# Access Compliance Report

## Public Rights-of-Way

### (Curb Ramps)

Intersection ID: 48555	Main Street: COTTON_PRESS_RD	Cross Street: RIDGEFOREST_DR	Location: E
ADA ID: 2C376C8167A3	Ramp Type: PerpDiag	Initial Pass/Fail: Pass	Overall Compliance: No
		Severity Score: 7.5

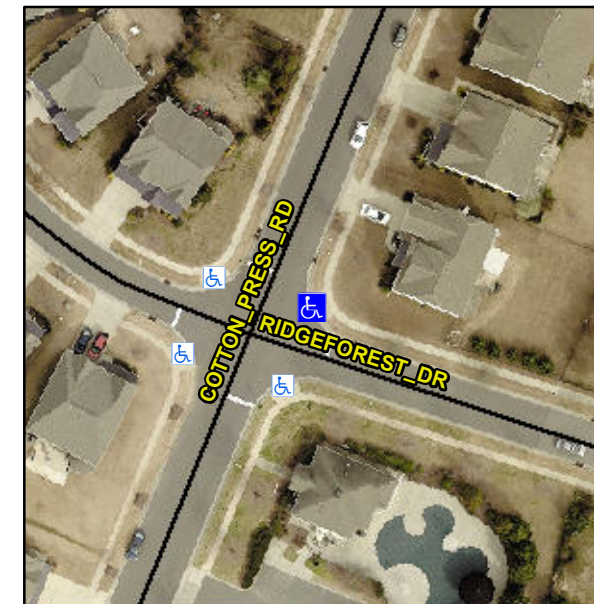
**R302.7.2**

Compliance	Description	Data	Compliance	Description	Data
N/A	Ramp Length (in)	71.0	Yes	Ramp Slope (%)	6.3
Yes	Ramp Width (in)	48.0	Yes	Ramp XSlope (%)	1.8
N/A	Flare Type LT	Sloped	N/A	Flare Type RT	N/A
N/A	Flare Slope LT (%)	5.2	Yes	Flare Slope RT (%)	5.3
N/A	Flare Traversable LT?	Yes	N/A	Flare Traversable RT?	Yes
Yes	Landing Length (in)	48.0	Yes	DWS Provided?	Yes
Yes	Landing Width (in)	48.0	Yes	DWS Contrast?	Yes
Yes	Landing Slope (%)	0.5	Yes	DWS Length (in)	24.5
Yes	Landing X Slope (%)	1.2	Yes	DWS Full Width?	Yes
N/A	Landing Curb? (Y/N)	No	Yes	DWS Offset (in)	1.0
N/A	Shared Landing?	No			
Yes	Gutter Ponding?	No	Yes	Gutter Slope (%)	1.9
No	Gutter Lip Ht (in)	0.5	Yes	Gutter X Slope (%)	0.2
N/A	Painted X Walk1?	No	N/A	Painted X Walk2?	No
	X Walk 1 Direction	To NW		X Walk 2 Direction	To SW
N/A	X Walk 1 Width (in)	N/A	N/A	X Walk 2 Width (in)	N/A
	X Walk 1 Slope (%)	1.4		X Walk 2 Slope (%)	0.7
	X Walk 1 X Slope (%)	0.5		X Walk 2 X Slope (%)	1.3

N/A	Ramp inside XWalk1?	N/A	N/A	Ramp inside XWalk2?	N/A
	Road Slope (%)	0.5	N/A	Clear Space?	Yes
	Road X Slope (%)	1.5	N/A	Clear Space to XWalk (in)	N/A
Yes	Any Obstructions?	No	Yes	Storm Grate/Utility Hazard?	No
	Obstruction Type			Storm Grate/Utility Type	
		N/A			N/A
			Yes	Surface Condition? (G/P)	Good

**Grind Gutter Lip.**
